Safety Evaluation East Bay Municipal District Wastewater Treatment Plant

Client: Advanced Engine Technologies Corp.

Submitted by:
Jim Dyer, Principal Engineer
Neil Holmgren, President
09/22/2020

Figure 2 – Installed LPDG Labeling

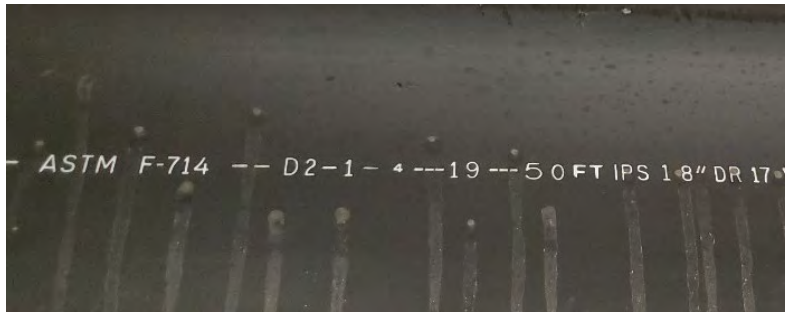
Additionally, closer inspection of the PE piping showed that it was not compliant with NFPA 54. *Figure 2* shows the piping marked ASTM F-714. NFPA 54 states that PE piping used for fuel gas is required to be marked “gas” and “ASTM D2513”.

The polyethylene section of piping in the engine room should be replaced with code compliant steel piping.

Figure 3: PGS-1 Fire Detection Panel Internal Wiring

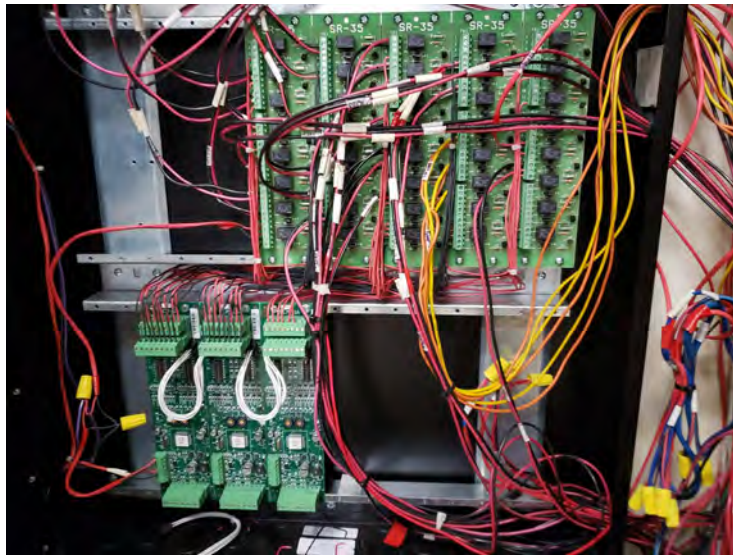
Investigation of the Fire Detection System revealed that much of the documentation was out of date. Shop drawings for fire alarm systems have many requirements including the "interface of fire safety control functions." Comparison of the drawings (Fire Alarm System Upgrade, Sheet FA-04) to the system as wired revealed many discrepancies largely related to the integrated functions (Fire Detection System Outputs). The following outputs were listed in the drawings but did not have wiring terminated in the panel:

Additionally, the following items were installed differently than depicted in the drawings:

1. Generator #1 - labeled as "Fire Alarm" on input to upper terminal block to MIP. Labeled as "MIP Fire +(-)" at output of terminal block.
2. Magnetic Fire Door Holder - drawing shows wires to NC contact (17, 18). Actually, wired to NO contact (18, 19)

3. To Heat Pump Control - drawing shows wires to NC contact (21, 22). Actually, wired to NO contact (22, 23)

A complete and accurate set of *as built* drawings are required to conform to code. Inspection of the panels, circuit tracing, and testing will be required to determine the "as-built" condition of the Fire Detection System. This is essential for plant personnel to understand the proper operation, have accurate expectations during testing or an emergency event, and troubleshoot the system should expectations not be met.

Figure 4: PGS-1 Control Room Fire Alarm Pull Station

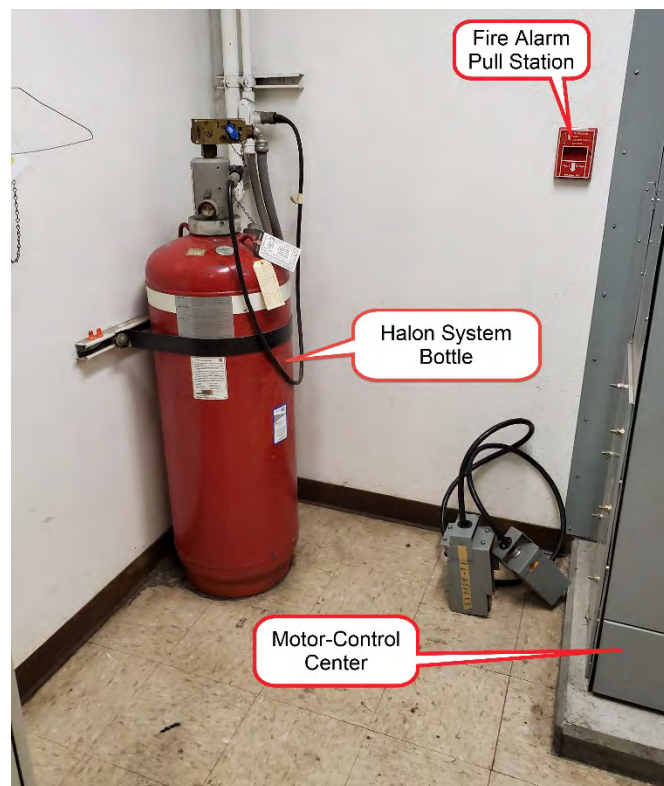
California Code and NFPA requires the fire alarm manual pull stations be located within 5 feet of each exit from the protected space. The PGS-1 control room was modified with a new motor-control center installed against the south wall. When this was done, one of the exit doors for the control room was blocked by the new equipment. The fire alarm pull station was located adjacent to this abandoned door (*Figure 4*) that was covered by the motor-control center. The current exit from the control room is on the opposite side of motor control center outside of the 5 feet requirement. It there is not a pull station located adjacent to the door exiting to outside this pull station needs to be moved closer to the existing exit door.

Relocate the fire alarm manual pull station to a location adjacent to an exterior exit door.

Figure 6: Engine Fuel Gas Metering Valve and Gas Header

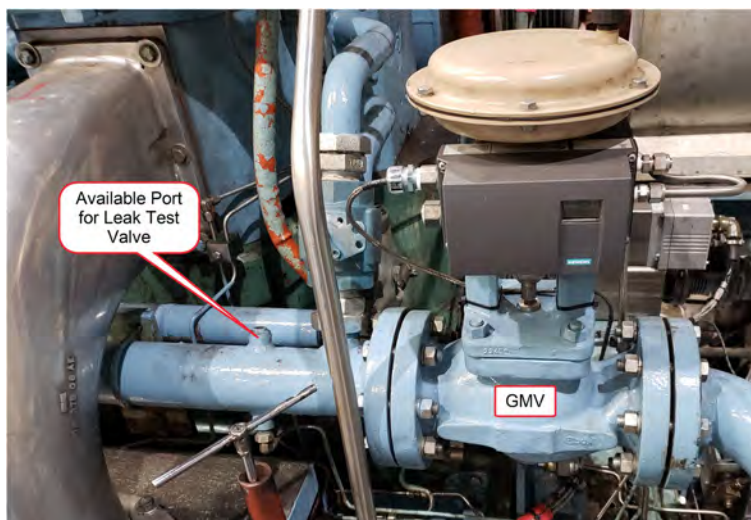
No leak test valves were installed downstream of the GMVs, but each engine has an available port for installation (*Figure 6*). A leak detection valve is not required between the ASSVs because the upstream ASSV vents to the PGS-1 roof when closed.

Install valves and plugs in available port for Leak Test valves. This can be performed by plant personnel, likely with instrument valves and fittings available on site.

Figure 9: Air Pressure Tank Certificate

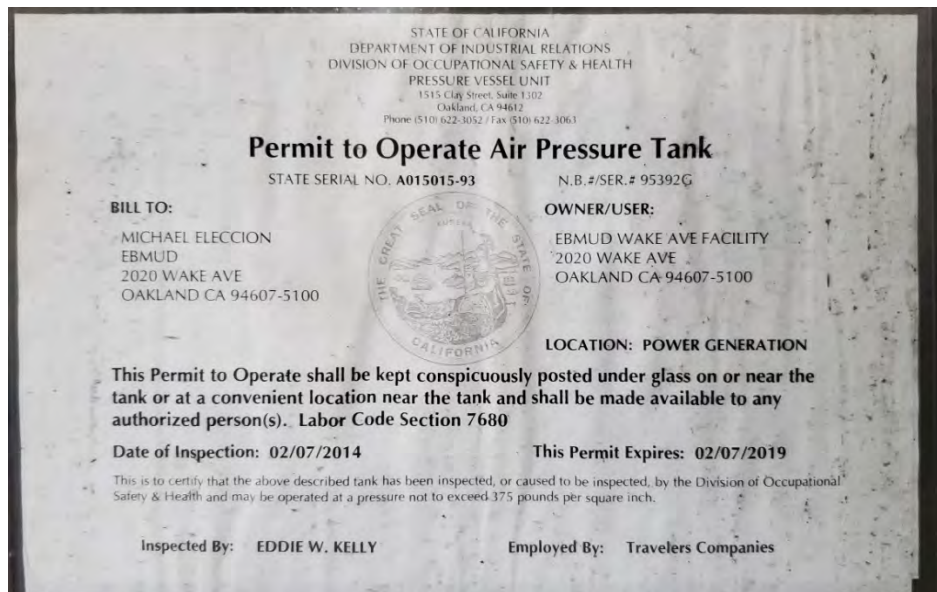
Air receivers were visually inspected. Two of the four had valid pressure tank permits, one permit had expired (*Figure 9*), and the last had no permit posted. California Labor Code 7684 states that “Each permit or a clear reproduced copy thereof shall be posted in a protective container in a conspicuous place on or near the tank...”

Determine if inspections were performed and permits not displayed. If inspections were not performed, request an inspection by contacting the following:

Figure 10: Engine Fuel Gas Supply Hose

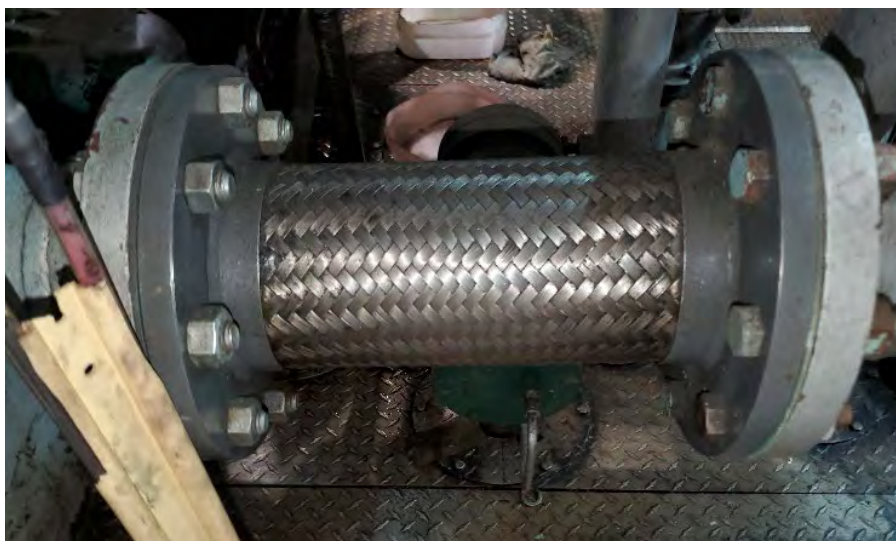
NFPA 54 requires that fuel gas connection hoses be UL Listed and rated for gas service meeting ANSI/CSA standards. The flexible hoses connecting the Fuel Gas Supply to the engines (*Figure 10*) have no labels to indicate that they are rated for gas service.

For ESI, these are familiar Enterprise hoses and appear to be (or equivalent to) the OEM units. The NFPA code does not require the hoses be labeled, they simply need to be compliant with ANSI/CSA standards. Without a label, the only way to prove compliance is with documentation from the OEM and tracking of the part through inventory and installation. New hoses will come labeled as compliant.

If these are indeed OEM hoses, no immediate remedy is required. Documentation may be requested with a Fire Marshall inspection. EBMUD may want to consider stocking labeled hose for the future.

Figure 11 - Uninsulated Elements of Exhaust and Jacket Water System

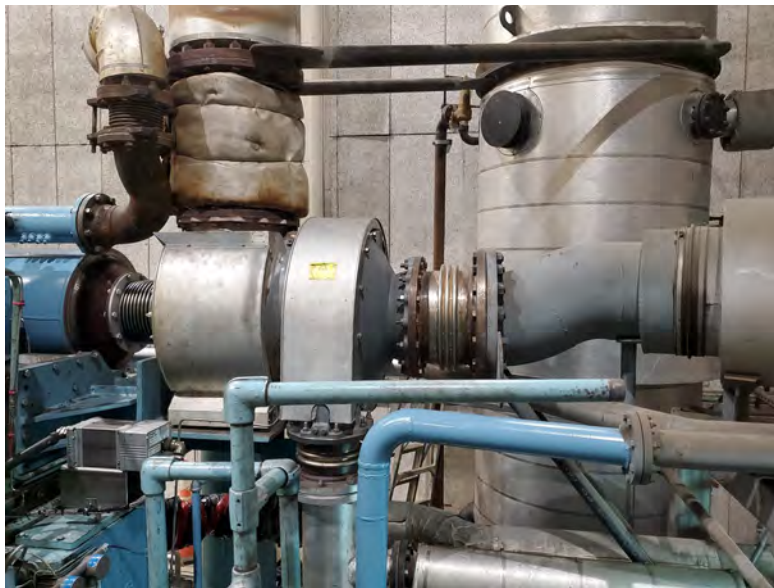
It is common for pipe insulation to be degraded through routine wear and tear during engine maintenance and especially during an overhaul. The engines were missing insulation on the exhaust and jacket water systems. Discussions with plant personnel indicated that the piping will be insulated at the completion of the current overhauls.

Insulate piping after completion of overhaul as currently planned.

Figure 14: Fuel Oil Tank Connections

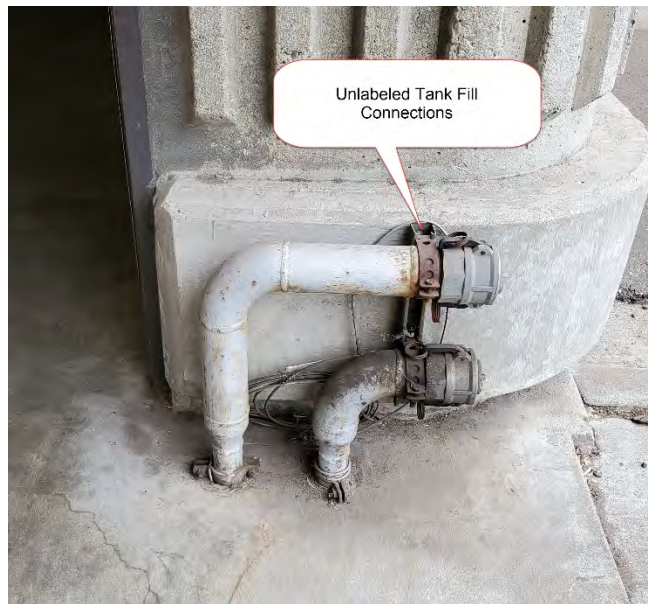
The diesel fuel tank loading connection is not marked to identify the product service (*Figure 14*). NFPA states, "Each loading and unloading riser shall be marked to identify the product for which it is to be used."

Provide proper markings for the Fuel Oil Storage tank fill connection.

Figure 16: Internals of PGS-1 Fire Detection Panel

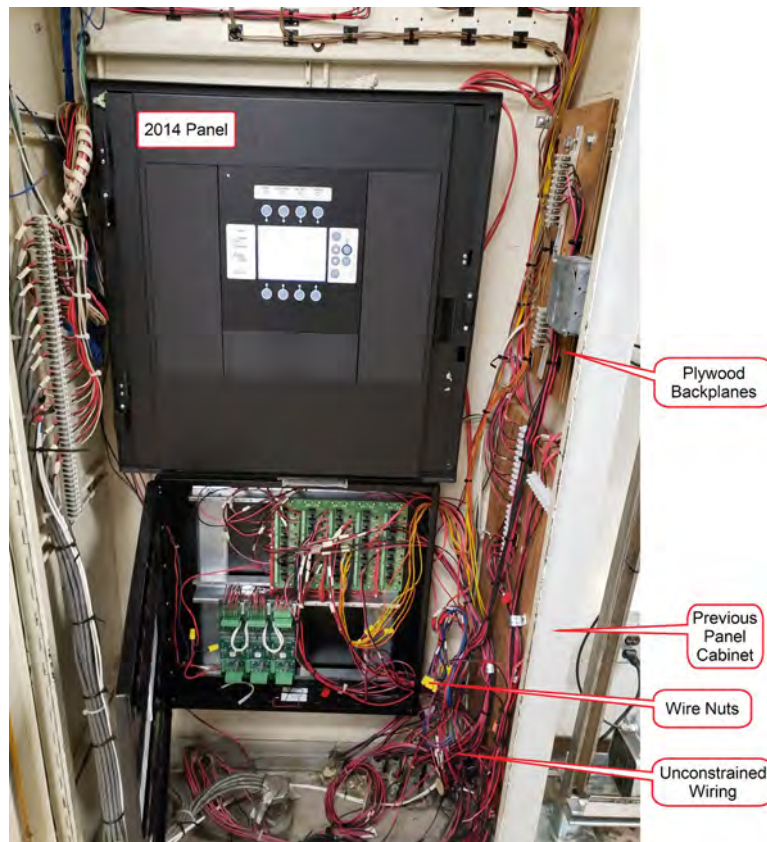
The Fire Detection System was upgraded in 2014. It appears that the new equipment was placed inside a previous system panel cabinet (*Figure 16*). The general condition of the wiring inside the panel was disarrayed. Specifics are detailed below.

Many of the wire labels were deteriorated and unreadable. This made troubleshooting difficult. Some wire labels changed as the conductor traversed the terminal blocks and did not match the drawings. Several terminal strips have been added to the panel in what appears to be an unplanned manner, some without labels for the terminal block or individual terminals.

The panel wiring layout should be cleaned up, wires relabeled as required, plywood backplanes replaced with DIN rail (or equivalent), terminal strips laid out logically to accommodate all wires (including spares), and Panduit (or equivalent) installed to neatly contain wiring. A new drawing should be produced that reflects the improvements.

Figure 18: Terminal Strip in PGS-1 Fire Detection Panel

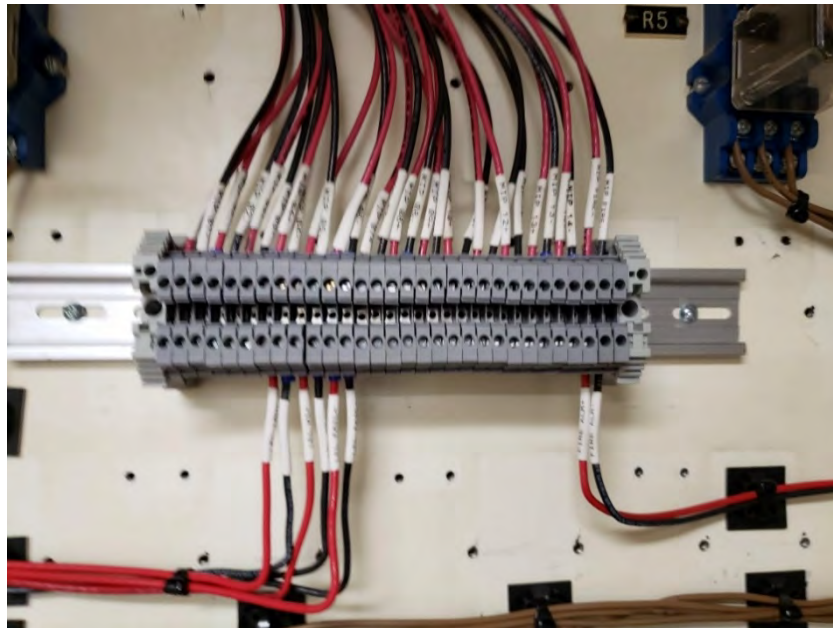
Some wires in the panel are dead ended at terminal strips (*Figure 18*). As stated above, this is acceptable for future expansion if the wires are labeled in the drawings. However, it is not known if these wires are spares or have been removed.

Figure 19: Plywood Backplane in PGS-1 Fire Detection Panel

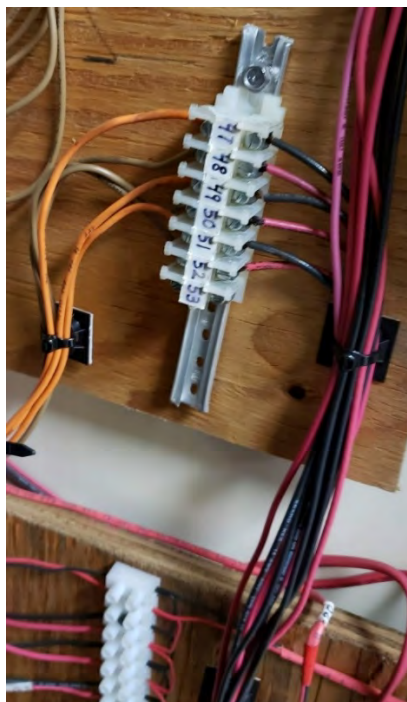
There are two plywood backplane panels installed in the Fire Detection cabinet. It appears that these are used to mount terminal strips. Plywood is not a standard industrial panel material due to the risk of fire and the insulating properties prevent the backplane from acting as part of the panel ground system.

Figure 20: Exterior Door to Fuel Oil Day Tank Room

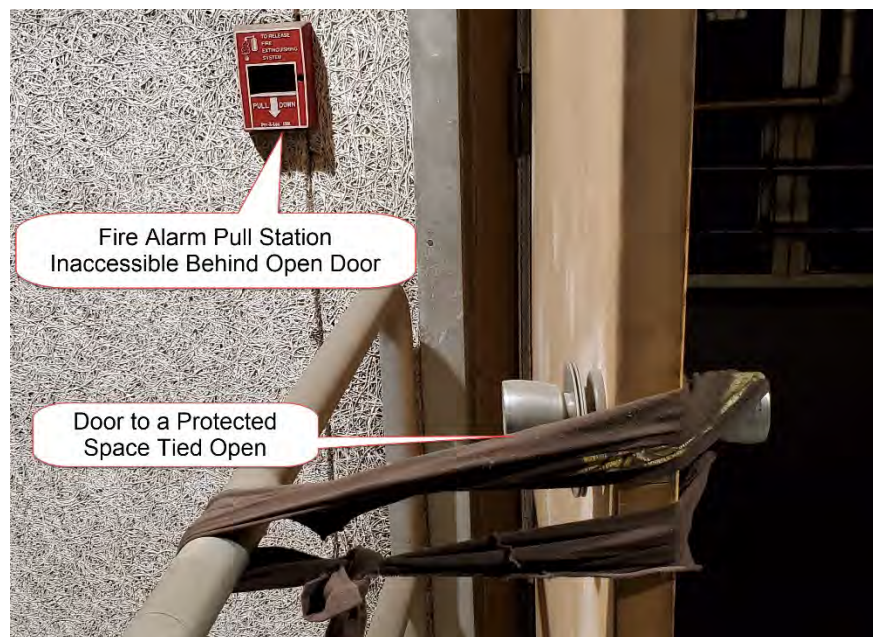
The exterior door to the Fuel Oil Day Tank room was tied open (*Figure 19*) during the site survey. The Fuel Oil Day Tank room is protected by the Halon system. The door needs to remain closed or be fitted with a magnetic hold that will release the door in the event of fire. The door closer will need to be routinely tested to ensure it effectively closes the door if this option is used.

The fire alarm pull station at the exit to the Fuel Oil Day Tank room is in a difficult spot to access (*Figure 20*), especially with the door held open. ESi recommends changing the orientation of this pull station to the door for better access. Even if the door is kept shut, it could become stuck open during an emergency egress making it difficult to reach the pull station. The door can be hinged on the opposite side or the pull station moved to the other side of the door.

Figure 21: Engine 2 Fuel Gas Supply Piping

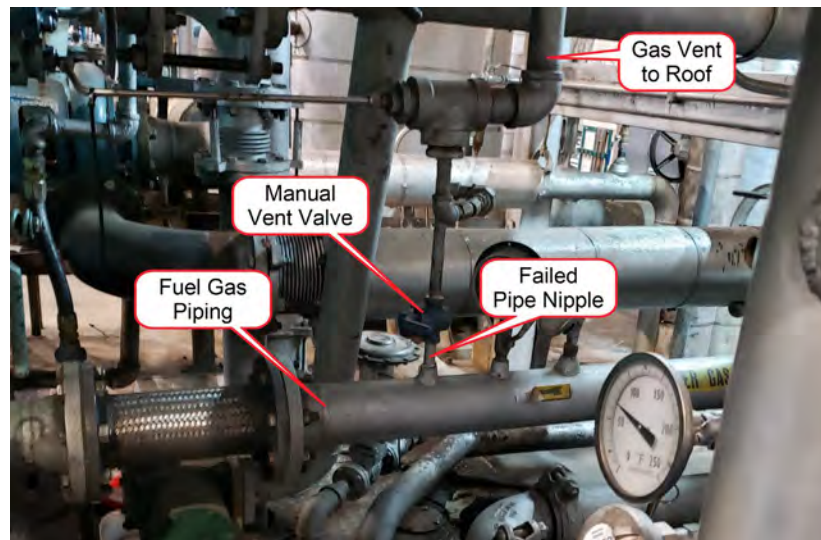
Discussions with plant personnel revealed that the piping for the manual gas vent on engine #2 failed at the pipe nipple between the fuel gas piping and the manual vent valve. The pipe nipple broke and separated the manual vent valve from the fuel gas line completely. As a result, pressurized fuel gas sprayed from the fuel gas line until the operator discovered the leak, switched the engine to diesel mode, and manually secured gas to the engine. The repair was performed prior to ESI's discussion with the operator.

While the failure mode was not identified conclusively (ESI did not examine the failed components), it was likely caused by vibration. This means that manual vent piping was not properly supported and/or isolated from vibration.

Figure 22: Engine 2 Fuel Gas Vent Line

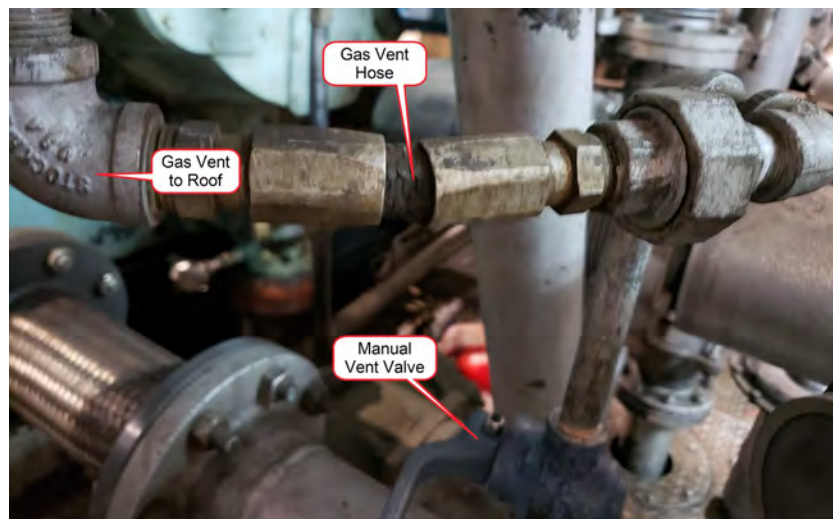
The vent line downstream of the manual vent valve connects to the gas vent to the roof via a short hose (Figure 22). This hose is too short to provide any meaningful vibration isolation.

For a hose to provide vibration protection, there needs to be room for the hose to move. Most hose manufactures will require a curve, belly, or “S” to be present in the hose after installation. *Figure 23* depicts an installation recommendation from a typical manufacturer.

Proper installation will allow for more flexibility in the hose connection allowing for better vibration isolation.

Figure 25: Modified Fuel Oil Elbow

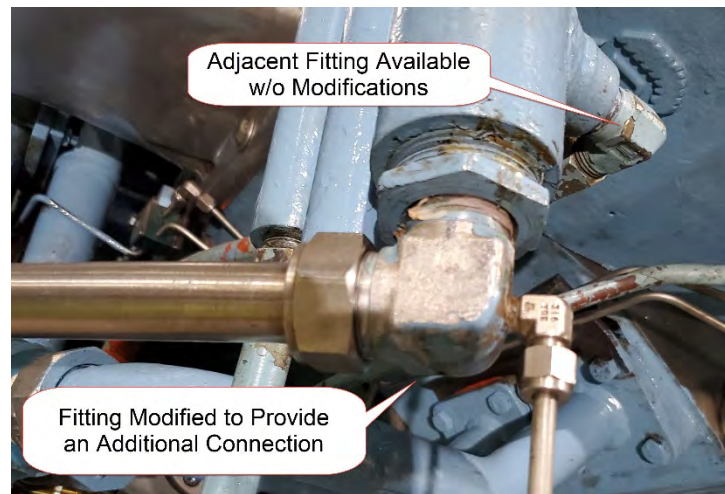
The engine Fuel Oil system contained many modified fittings, mostly around the micro-pilot fuel system. These fittings are not installed as designed and little is known about the quality of the modification. Proper fitting selection from the Swagelok catalog could have been substituted for these modifications. *Figure 25* is a typical modification identified by ESI. It appears that the original fitting was drilled/tapped for insertion of a new fitting. In this case, there is an additional port that could have received the proper Swagelok fitting in lieu of modification to the elbow.

ESi recommends replacing these modified fittings with the proper selection of manufactured fittings as best practice.

Plant personnel can procure and replace modified fittings with manufactured fittings.

Figure 26: Modified Cooling Water Elbow

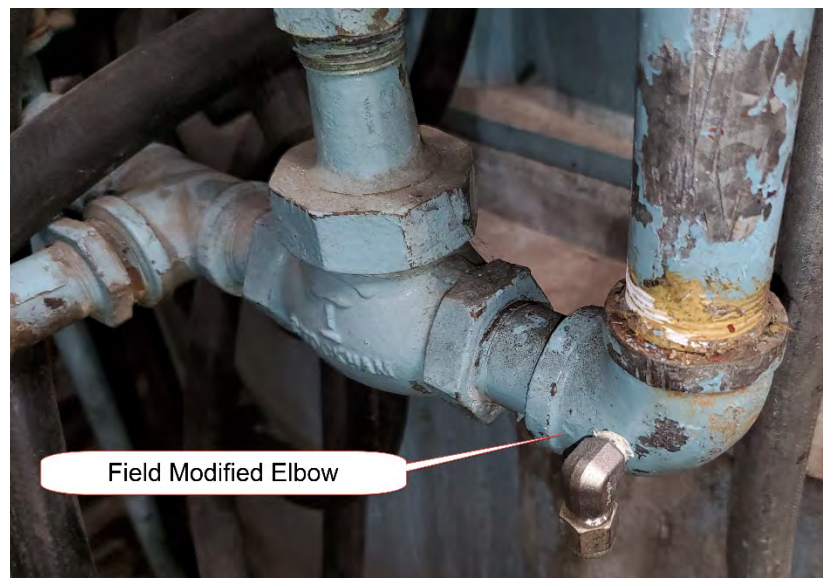
The cooling water systems contained modified fittings as well (*Figure 26*). These modification points can become sites for erosion or corrosion which can lead to leakage.

Figure 35: Fuel Oil Service Rack Designed by ESI with Fusible Link valve Connections

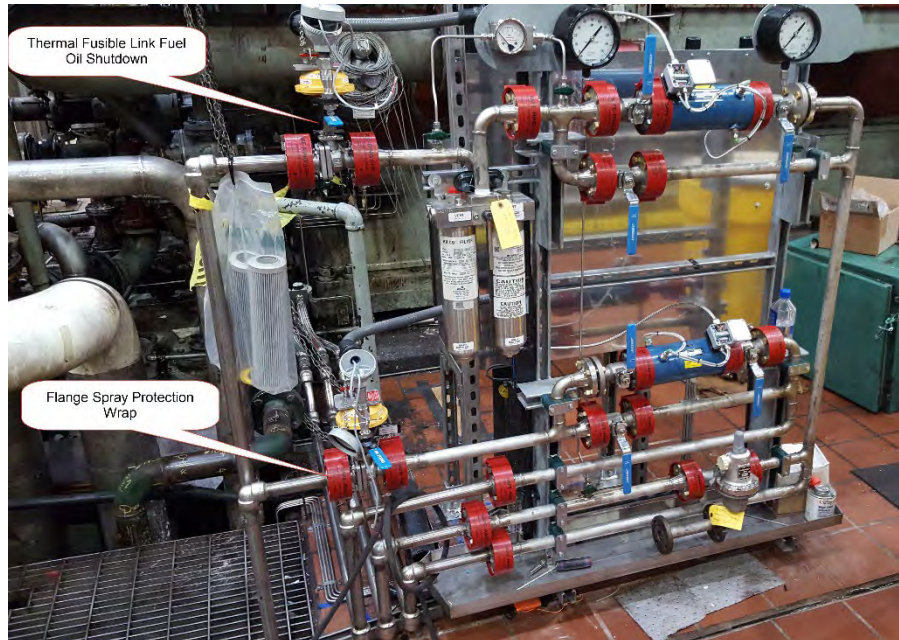
The use of thermal trip fusible link valves should also be considered in the fuel oil system. The engines are located two floors below and at a significant distance from the fuel oil pumps. Thermal shutoff valves installed adjacent to the engine would reduce automatic shutoff time for an engine or generator fire. A shutoff valve should be provided for all fuel sources (oil and fuel gas).
